**MAINE TURNPIKE AUTHORITY**

**ADDENDUM NO. 1**

**CONTRACT 2022.08**

**LITCHFIELD 8-BAY GARAGE REPLACEMENT**

LITCHFIELD 8-BAY GARAGE REPLACEMENT  
MECHANICAL PLAN

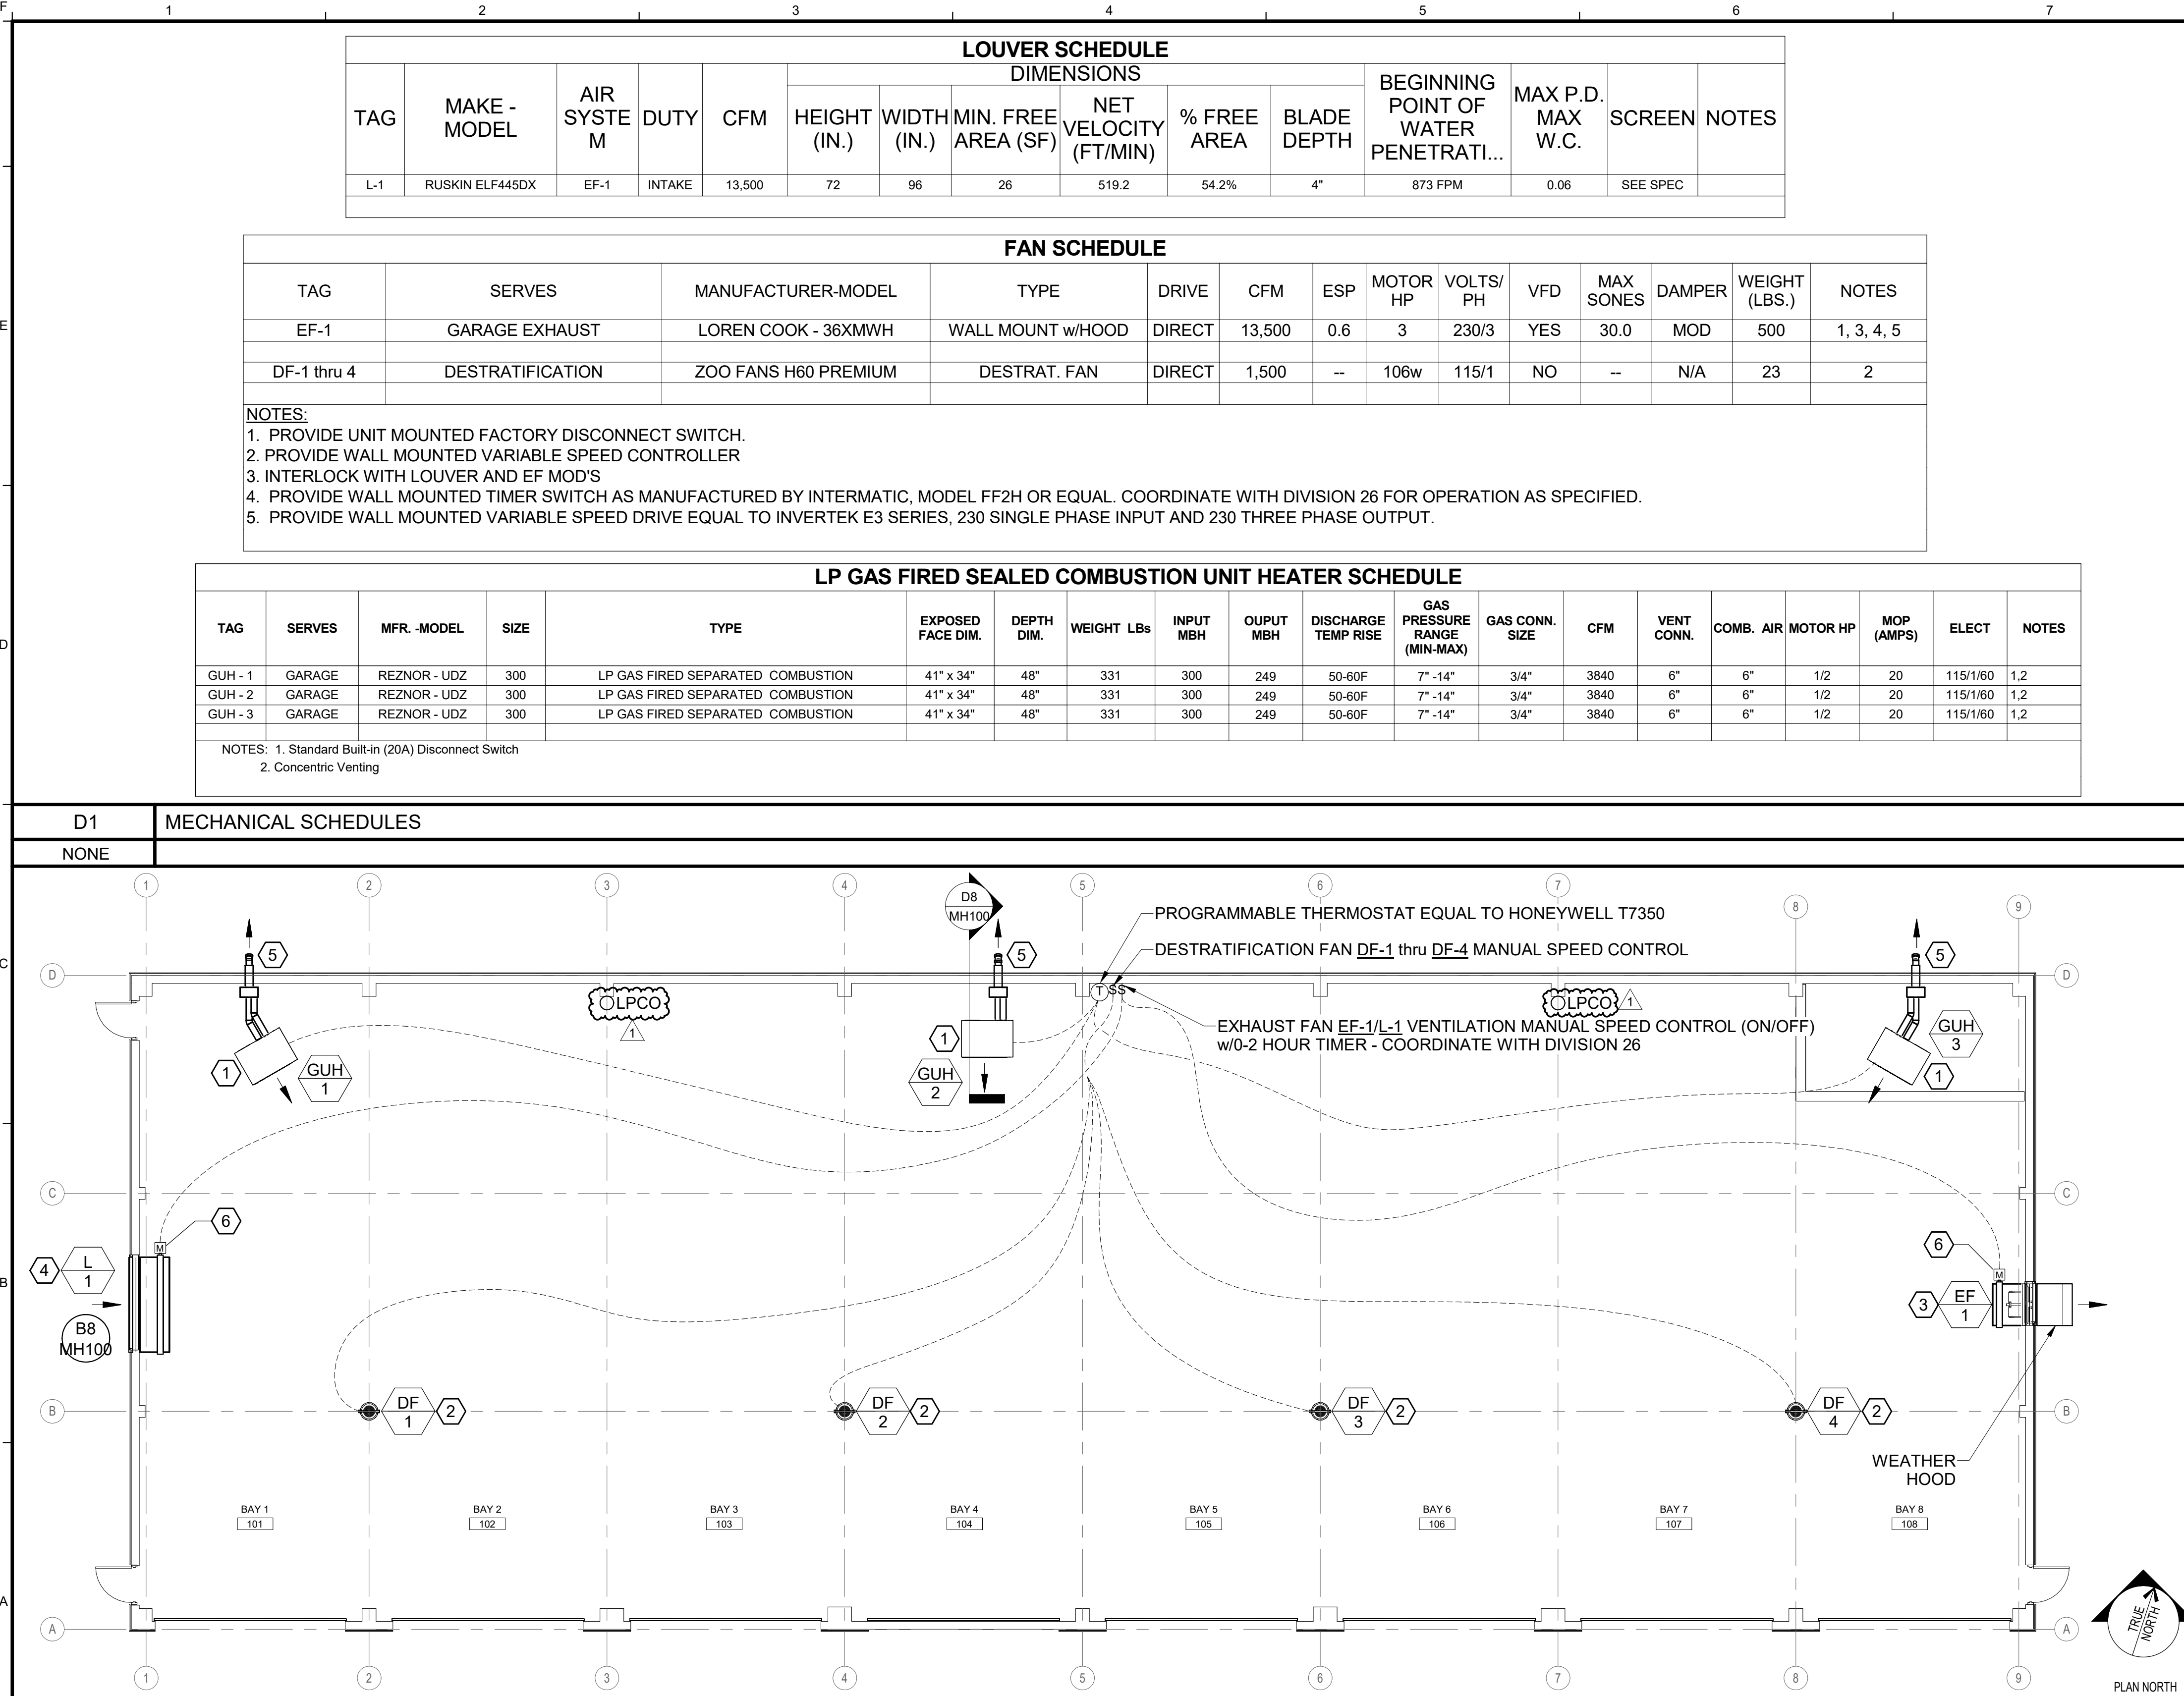
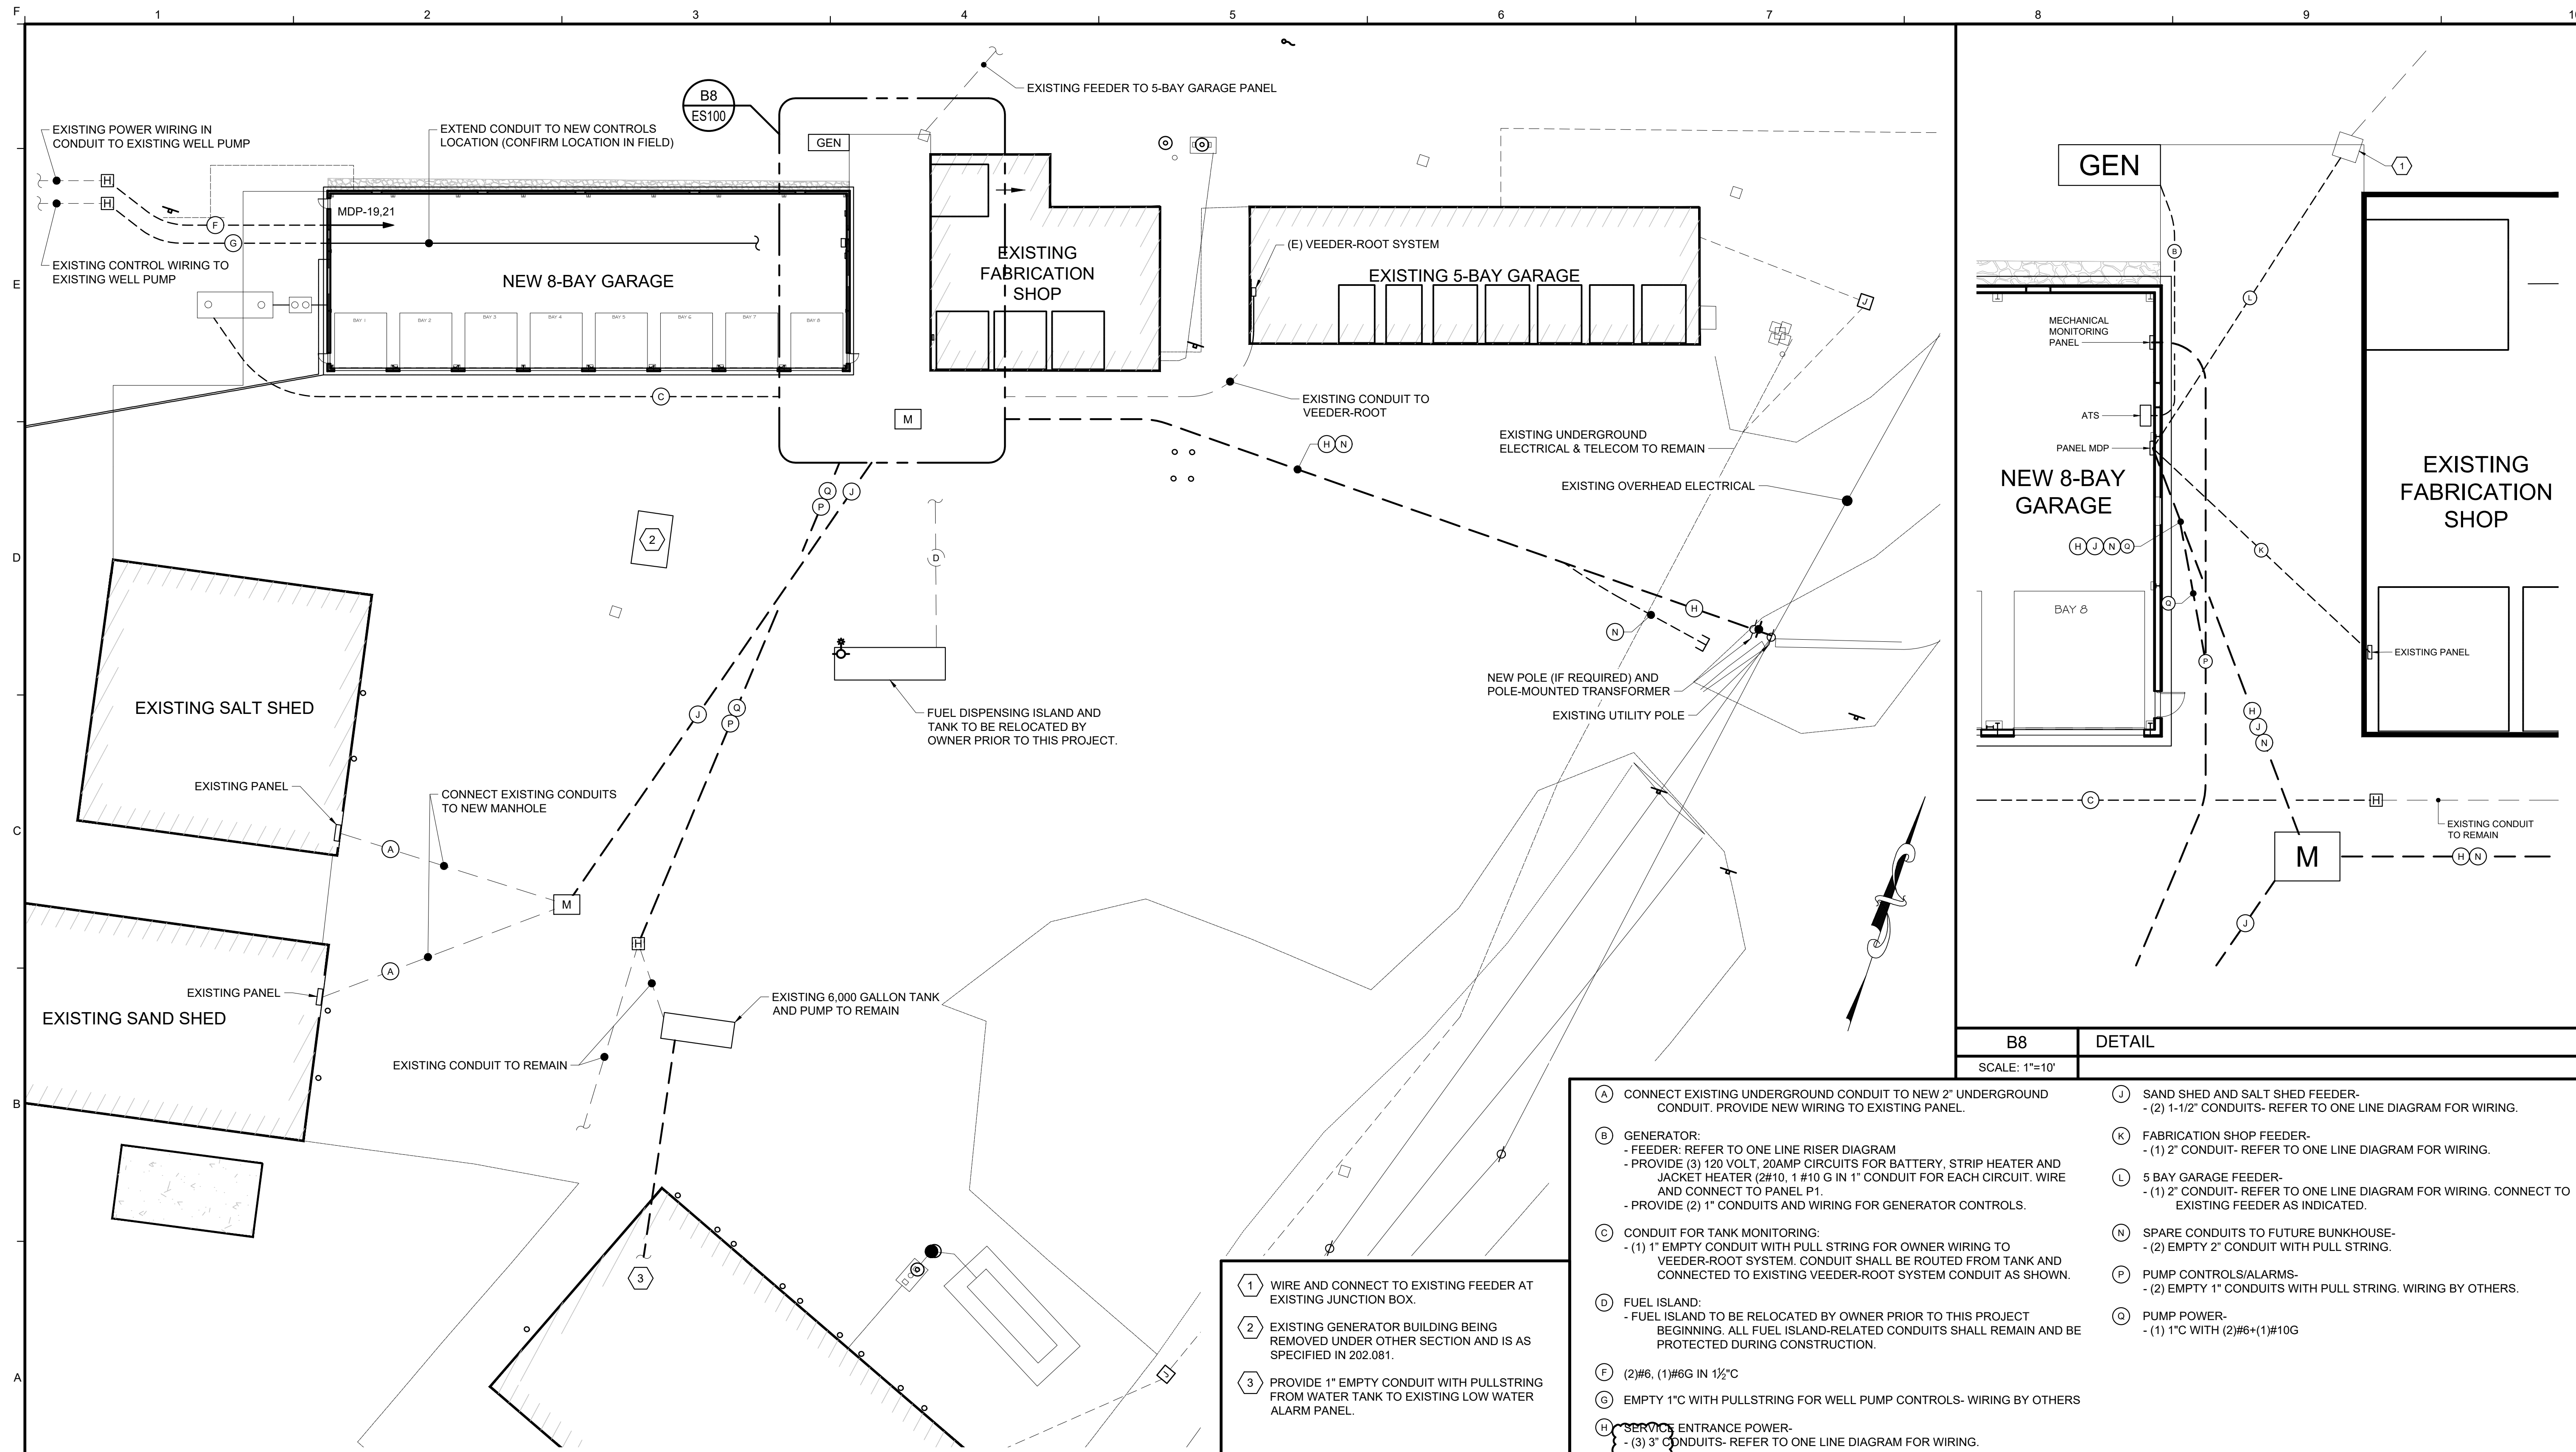
- Plan Sheet 28 - Mechanical Plan: **DELETE** the sheet and **REPLACE** it with Plan Sheet 28, attached hereto with revisions.
- Plan Sheet 31 – Electrical Site Plan: **DELETE** the sheet and **REPLACE** it with Plan Sheet 31, attached hereto with revisions.

| <b>A1 POWER AND SYSTEMS PLAN</b>             |                      |  |            |                     |  |

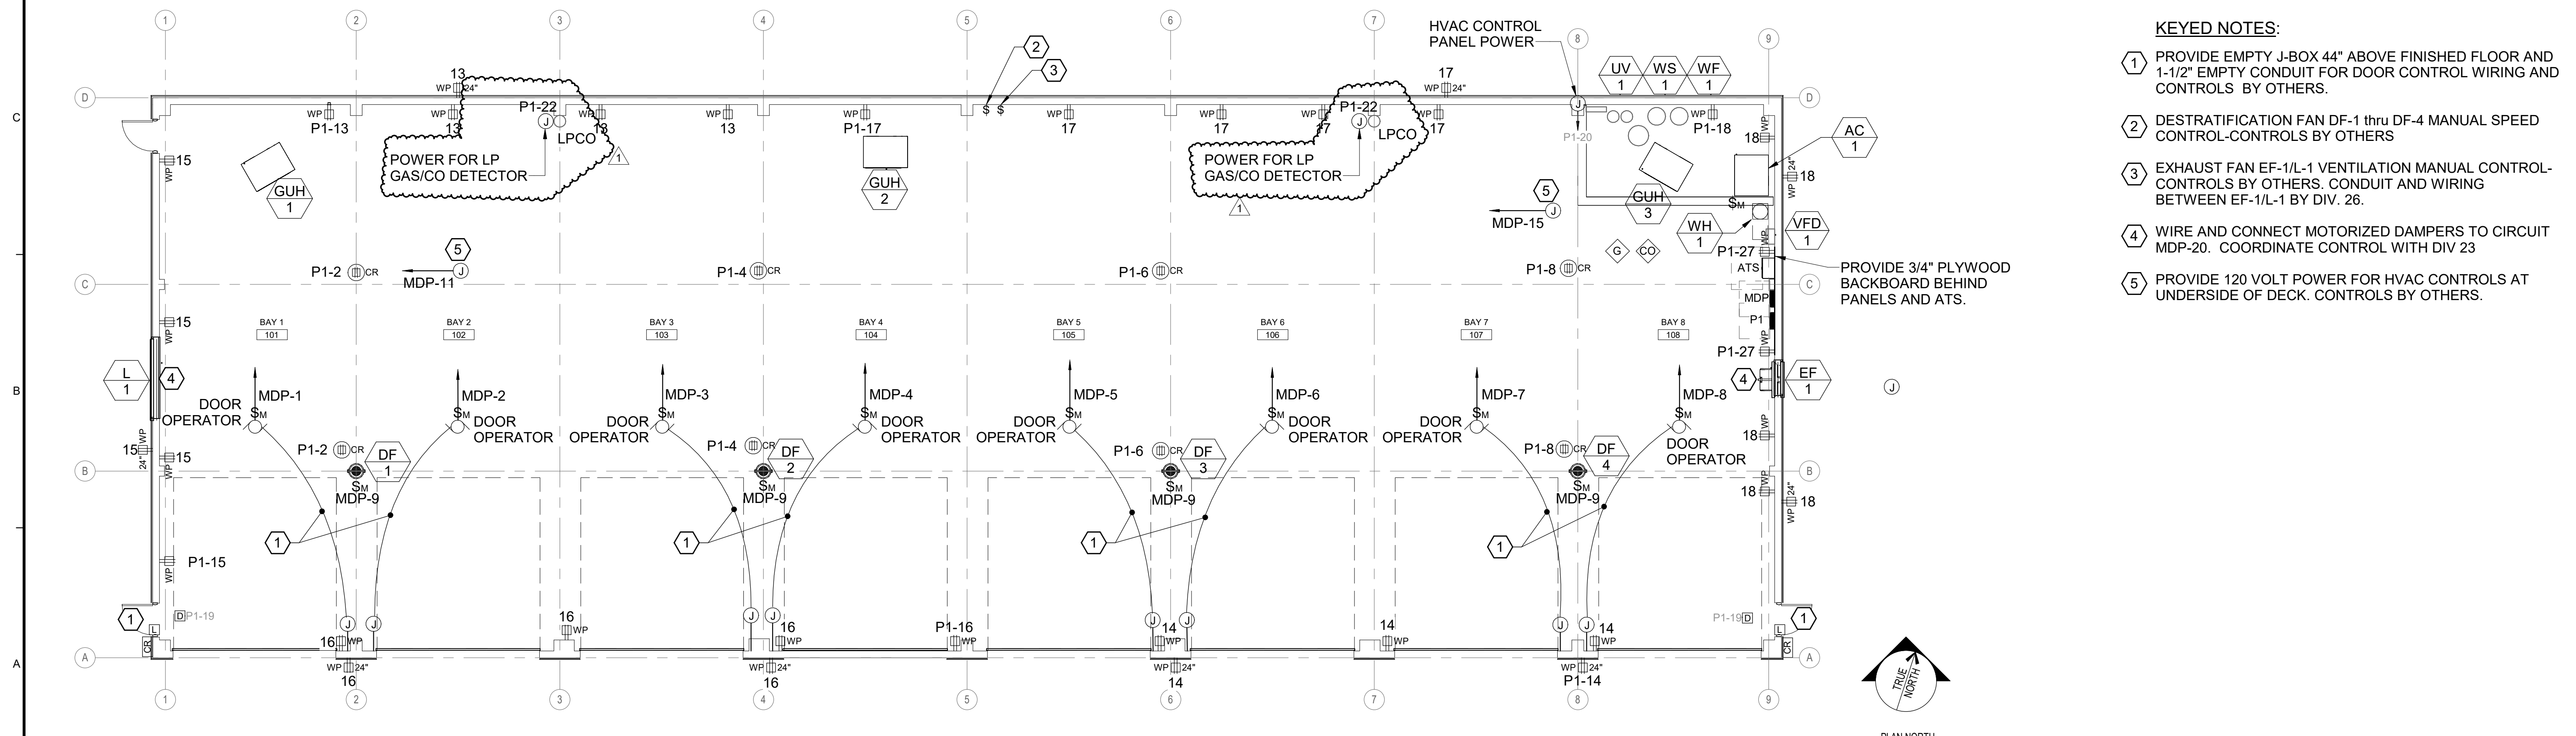
- Plan Sheet 34, Power and Systems Plan: **DELETE** the sheet and **REPLACE** it with Plan Sheet 34, attached hereto with revisions.

Question 2: Does specification section 27 Communications Equipment Room Fittings apply to this project? There is only one tel/data jack shown, and no data cabinet or tel/data underground entrance conduits shown on the drawings.

Question 15: I do not see anything in the plans relating to fire alarm requirements with the exception of local alarms. With the project using LP for heat as well as the fuel island I would think it would be required.

Question 17: The Conduits to the future bunk house are shown on the one line drawing to be 2-3” conduits but on the site drawing they are shown to be 2-2”. Which is correct?

Answer: Sheet 34 is reissued with this addendum and Special Provision Section 271100 is removed from the Contract package. These revisions address this question.

Answer: Sheet 34 reissued with this addendum addresses this question. Two LP Gas and Carbon Monoxide Detectors have been added. There are no other fire alarms in the building as none are required by code.

Answer: The change to sheet 34 included in this addendum addresses this question.
